NEW SUMMARY OF SUBMISSIONS
Doley road Precinct / Amendment to Town Planning Scheme No. 2 - Local Structure Plan
PA20/532

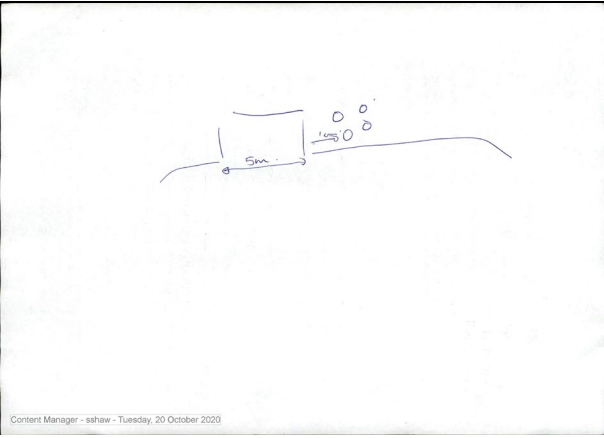
G. Reynolds IN20/25375	19.	<ul style="list-style-type: none"> - Old Crossover is not wide enough - Hard to see to the right exciting the property - Pipework has collapsed underneath 	<p>The specific location of the subject comment is unclear.</p> <p>It is assumed the comment refers to the area marked blue in the centre image below providing crossover</p>	Noted – We appreciate your response via submission to the Doley Road Precinct

Submitter	No	Submitter Comments	Applicant Response	Officer Comment & Recommendation
		 <p><small>Content Manager - sishaw - Tuesday, 20 October 2020</small></p>	<p>access from Lawrence way to 55 Lawrence Way.</p> <p>The existing crossover is suitable for residential domestic access only, and will require upgrading to service future development with respect to 55 Lawrence Way (Lot 61 D61334).</p>	<p>Amendment 1 – Local Structure Plan.</p>
